EL PASO COUNTY
PLANNING AND COMMUNITY DEVELOPMENT

SFD 19206
PLAT &
ZONE RR-5
DIST 1

Site Plan
6550 Echo Ridge Heights ✓ 36.14 acres ✓

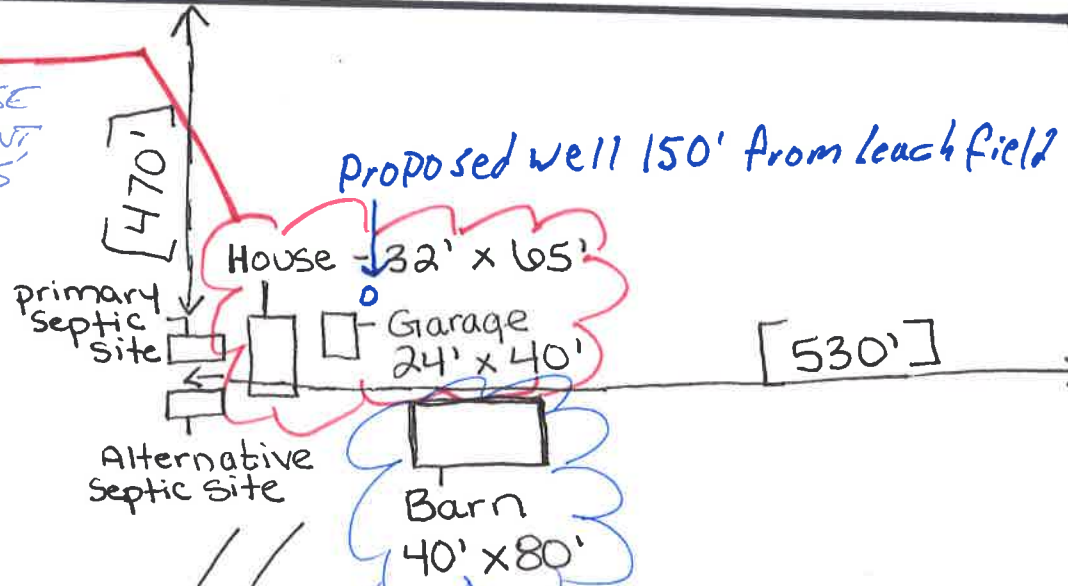
① MUST PROVIDE SETBACK MEASUREMENTS FROM HOUSE & DETACHED GARAGE TO FRONT, REAR & BOTH SIDE LOT LINES

③ RECORDS INDICATE A PERMIT HAS NOT BEEN ISSUED FOR 3200 BARN. APPLICANT MUST OBTAIN AN ACCESSORY STRUCTURE BLDG PERMIT FROM APPRD OR AN AGRICULTURAL STRUCTURE EXEMPTION FROM BLDG CODE AFFIDAVIT FROM PCD DEPENDING ON USE OF STRUCTURE TO BE IN COMPLIANCE W/ COUNTY CODE.

② LEGAL DESCRIPTION & TAX SCHEDULE NUMBER NEED TO BE PROVIDED ON SITE PLAN
